ST13-001

2013 JX; SERVICE KIT FOR STEERING GEAR AND HIGH PRESSURE HOSE REPLACEMENT

APPLIED VEHICLE 2013 JX (L50)
VIN AND DATE: built before 5N1AL0MM(*)DC 304569 and April 12, 2012
TRANSMISSION: AWD (RE0F09B) **Only**

Figure 1

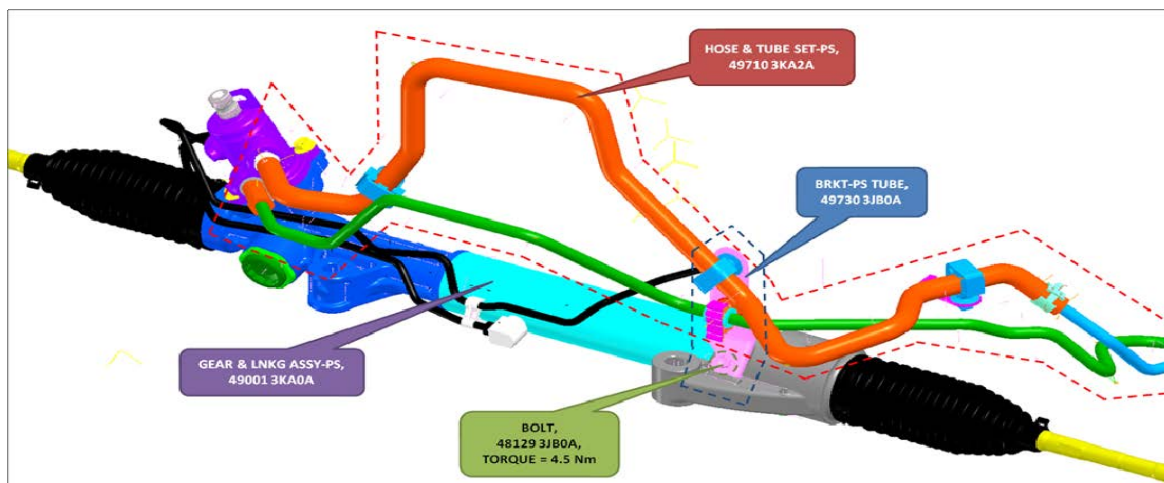
If the Power Steering Hose & Tube or the Power Steering Gear assemblies need to be replaced, please replace them with the service parts listed in the Parts Information below.

- See Fig. 1 for parts illustration.
- Refer to section ST (Steering System) of the applicable Electronic Service Manual (ESM) for the removal and installing instructions.

(1) ALL (3) parts **must** be replaced AS A SET.

- Replace old "BRKT - PS TUBE & old BOLT" on the Power Steering Gear with the new BRKT & BOLT above.

**Torque new BOLT to 4.5 N·m (0.50 Kg-m, 43 in-lb)

(1) **Must** be replaced AS A SET
